STATE OF NORTH CAROLINA
DEPARTMENT OF TRANSPORTATION

February 15, 2012
Revised March 15, 2012

SUBJECT: **Application for Section 404 Individual Permit, Section 401 Individual Water Quality Certification, and Randleman Lake Buffer Authorization** for the proposed improvement of Greensboro-High Point Road (SR 1486-SR 4121) from US 311 Bypass (future I-74) in High Point to Hilltop Road in Greensboro, Guilford County, Division 7. Federal Aid Project No. STP-4121(1), State Project No. 8.2491602, WBS Element No. 34802.1.1, TIP No. U-2412A&B/U-2524AE.

SITE 4
PLAN VIEW

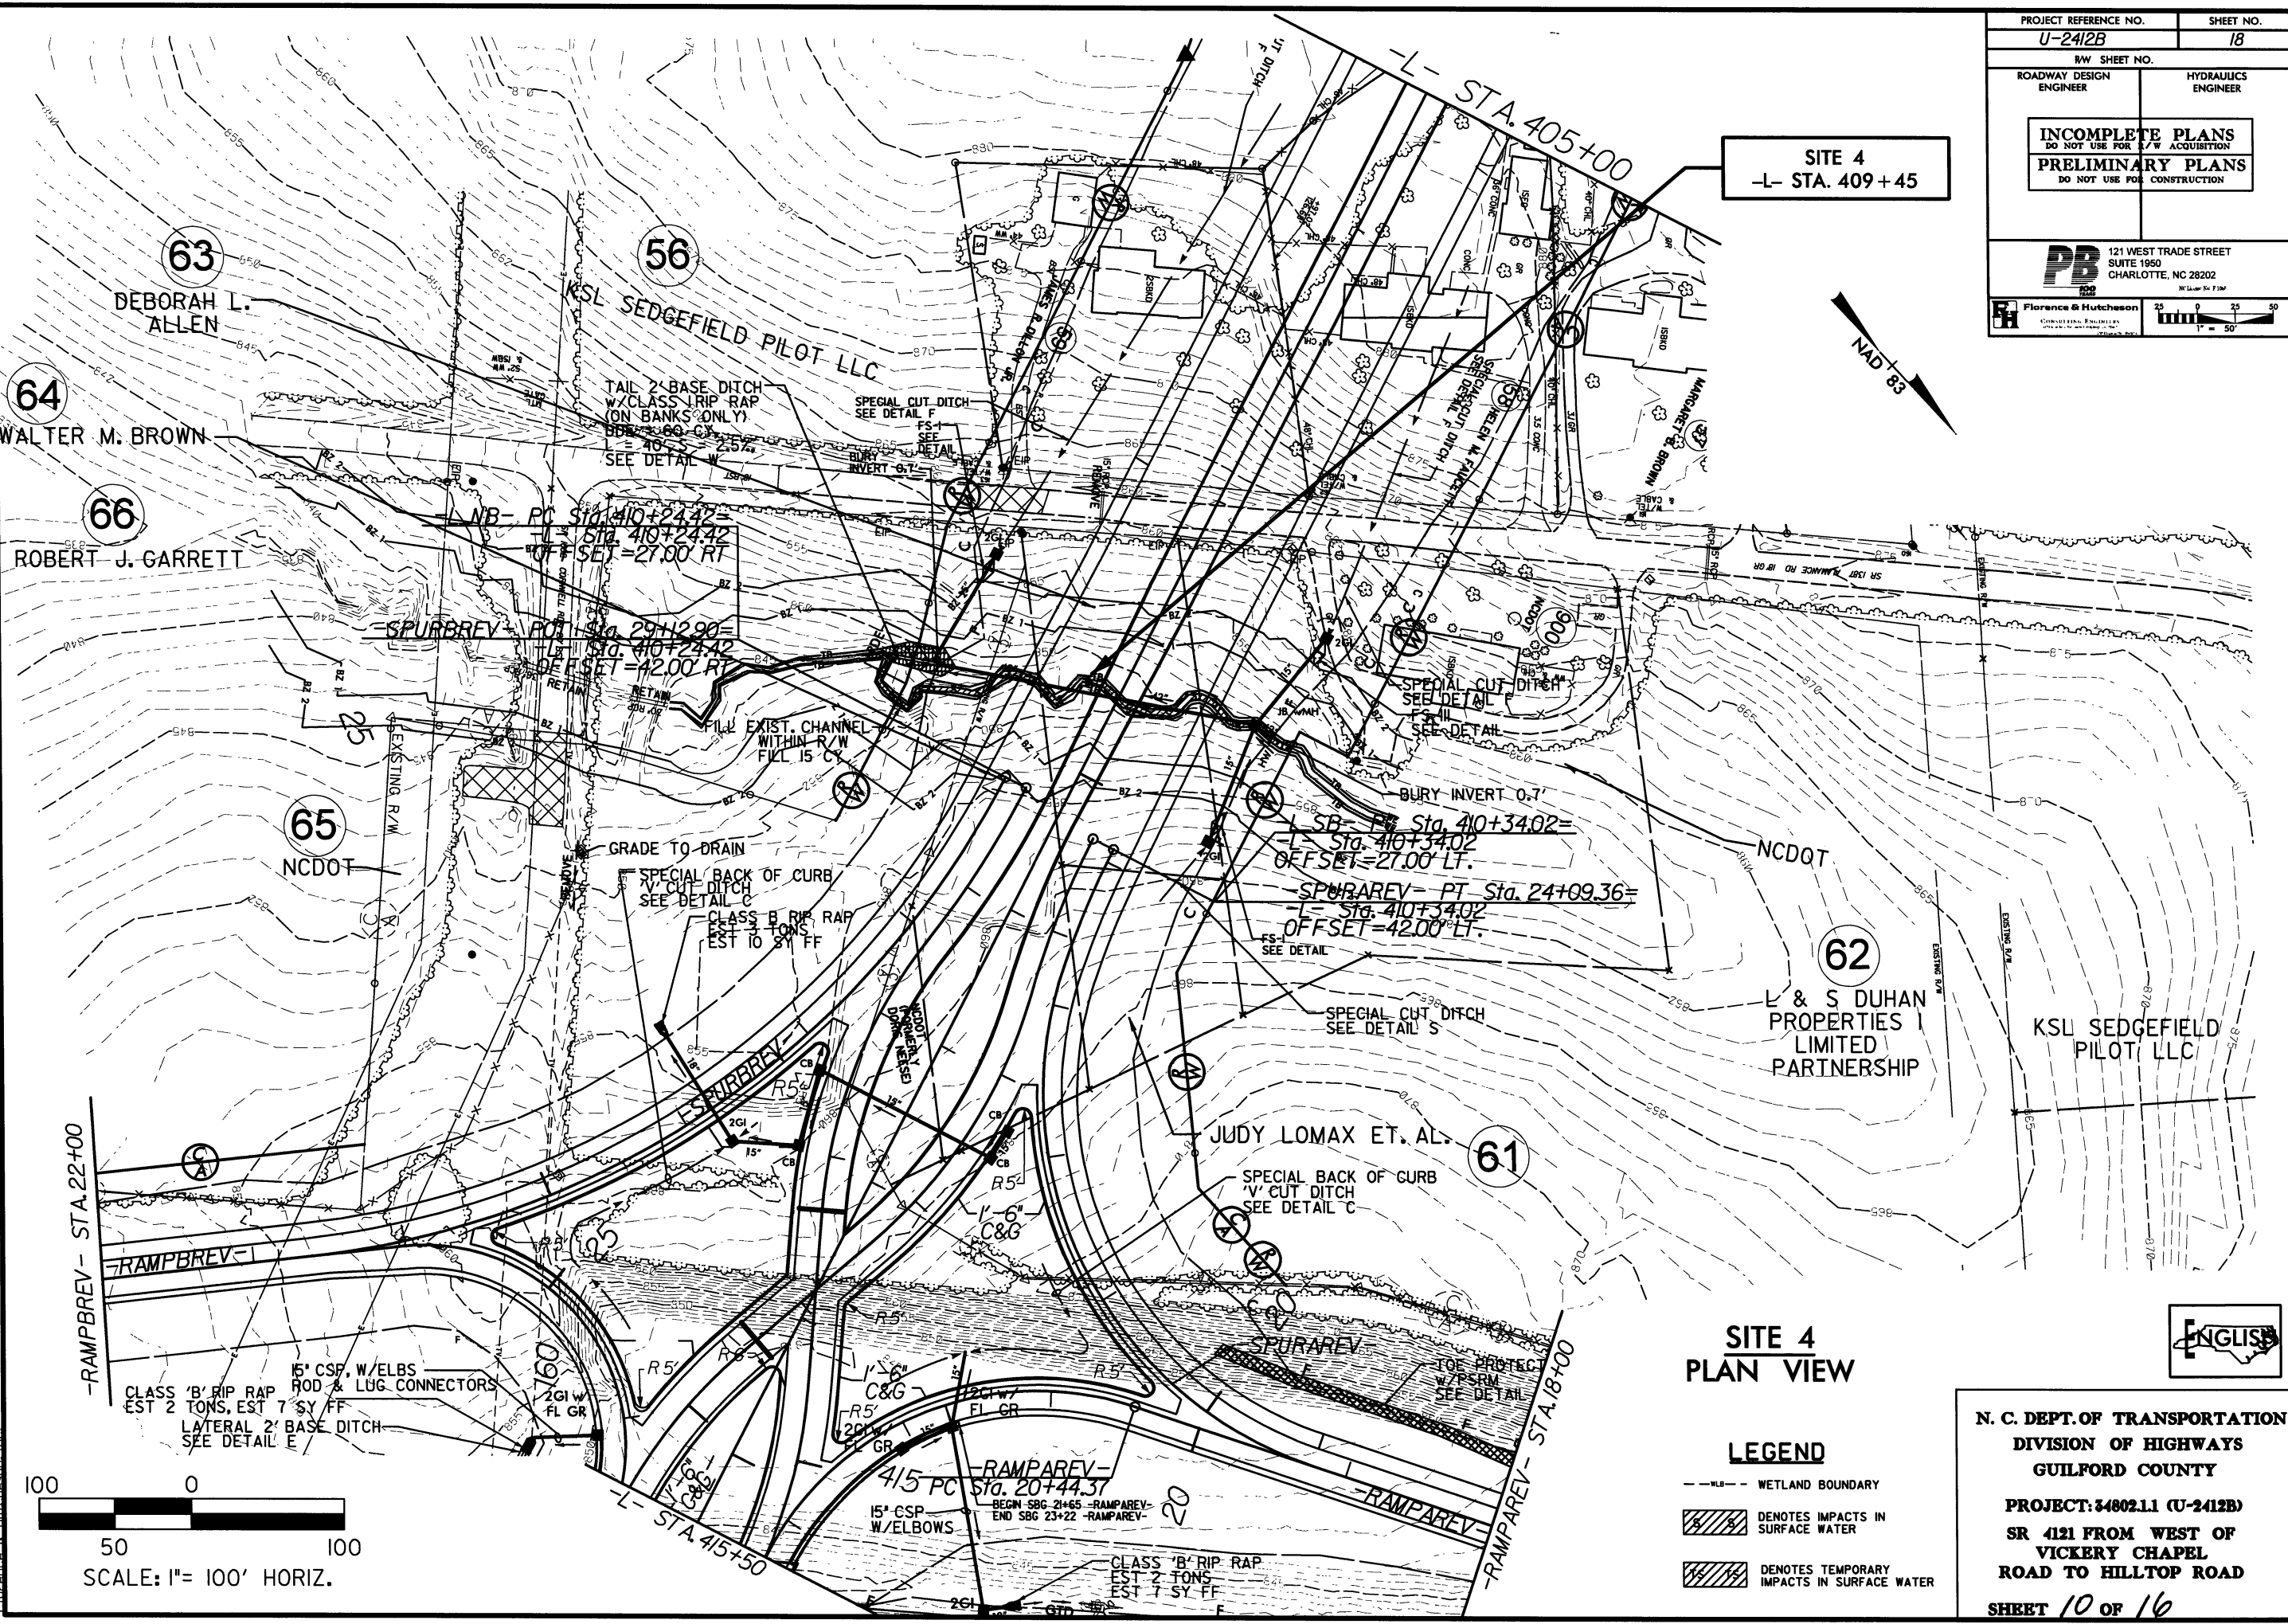
1. Combine Site 2 with Site 4 and label as Site 2 since they are along the same stream.
2. As indicated in SWMP for BMP at -RAMPB- 14+00 LT, F&H explained that the storm drain outlet pipe cannot daylight without a tail ditch. This tail ditch (0%) with rip rap (width from 5' to 15') will dissipate energy to provide a non-erosive diffused flow before entering wetland and buffer.
3. For Site 4, the buffer impact for the 30" pipe to the box culvert is mitigable.
